Well Name: CANAL 20/19 FED COM	Well Location: T21S / R27E / SEC 20 / NENE / 32.4700453 / -104.204714	County or Parish/State: EDDY / NM
Well Number: 851H	Type of Well: CONVENTIONAL GAS WELL	Allottee or Tribe Name:
Lease Number: NMNM0354232	Unit or CA Name:	Unit or CA Number:
US Well Number: 3001556334	Operator: MEWBOURNE OIL COMPANY

Sundry ID: 2863169

Type of Submission: Notice of Intent	Type of Action: APD Change
Date Sundry Submitted: 07/15/2025	Time Sundry Submitted: 08:22
Date proposed operation will begin: 07/16/2025

Procedure Description: Mewbourne Oil Company requests that the following change be made to the Canal 20/19 Fed Com #851H (30-015-56334): • MOC request to change the BHL f/ 490 FNL & 100 FWL (19) to 1810 FNL & 100 FWL (19). • Attached Dir Plan/Plot, Drlg Program, & C102 reflecting requested changes.

CANAL 20/19 FED COM #851H

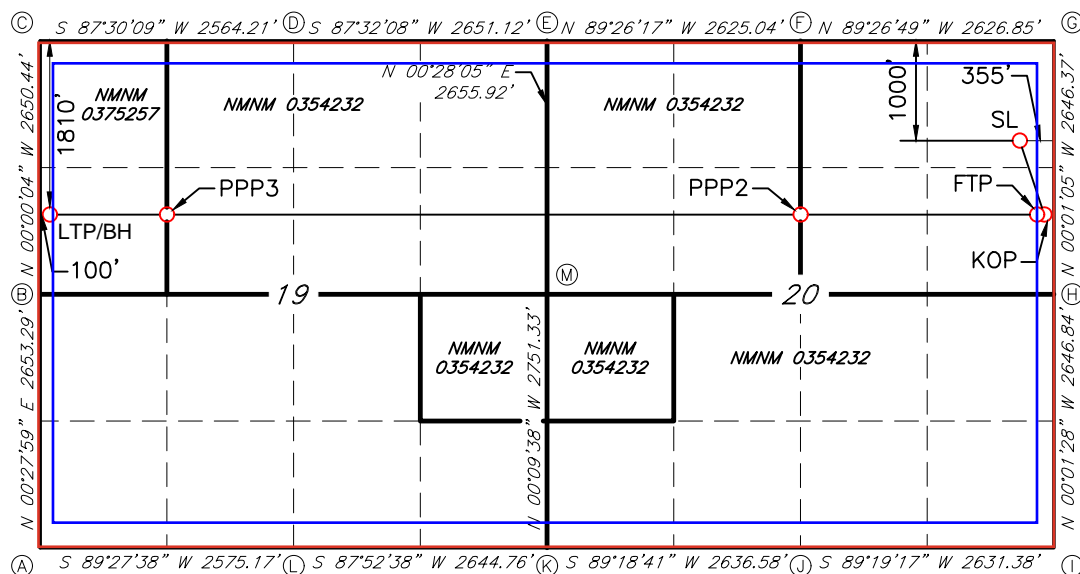
- MOC request to change the BHL f/ 490 FNL & 100 FWL (19) to 1810 FNL & 100 FWL (19).
- Attached Dir Plan/Plot, Drlg Program, & C102 reflecting requested changes.

UL E	Section 19	Township 21S	Range 27E	Lot	Ft. from N/S 1810 FNL	Ft. from E/W 100 FWL	Latitude 32.4673708°N	Longitude 104.2371592°W	County EDDY
----------------	----------------------	------------------------	---------------------	-----	---------------------------------	--------------------------------	---------------------------------	-----------------------------------	-----------------------
